## Design Review Board Study Session

SUBJECT: DR14-41, PRIMROSE PRESCHOOL

DR14-41, Primrose Preschool: site plan, landscape plan, grading and drainage, elevations, floor plans, lighting, colors and materials for approximately 1.57 acres located at the southwest corner of Val Vista Drive and Germann Road zoned Shopping Center (SC) with a Planned Area Development (PAD) overlay.

**DR14-41: Primrose Preschool Exhibit 3 - Site Plan**

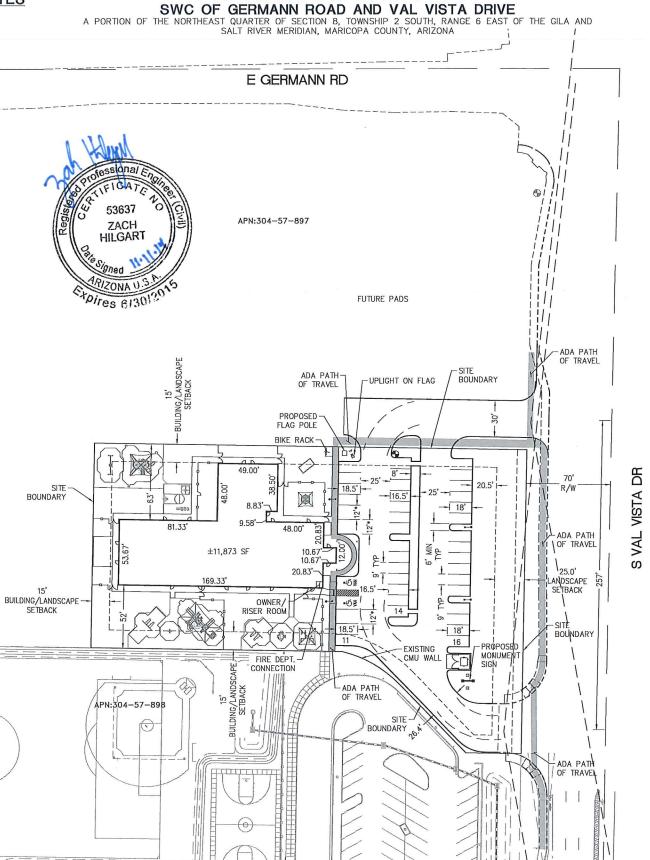
- 1. Staff will request verification of recorded cross access agreement and construction agreement for the north shared access drive. If none are in place, staff will request they be recorded prior to construction permitting.
- 2. Per Code, parking and drive aisle screening are required.
- 3. Required parking is 40 spaces and passenger loading is 3 spaces for a total of 43 spaces. The site plan is short two spaces.
- 4. Staff is also concerned that the refuse enclosure does not meet Public Work's standards and will block the visibility of the proposed monument sign.
- 5. Connectivity from the surrounding neighborhood was a large part of the rezoning discussion and preliminary plat for Villages at Val Vista. Ball Charter School connected to the sidewalk from the south and provided access across their site to the north via an 8'

- sidewalk. Staff is requesting that the Primrose Preschool applicant match the sidewalk width and location because what is shown on the site plan is not sufficient.
- 6. The landscape palette shall be adjusted to match Village at Val Vista streetscape.
- 7. The retention basin along Val Vista shall be adjusted for a more natural appearance.
- 8. The Floor Plans and Elevations match the other existing Primrose Preschool in Town.
- 9. Staff has no outstanding issues with the colors and materials.
- 10. Staff will request full details and cut sheets on all of the site furnishings, shade canopies and fencing.
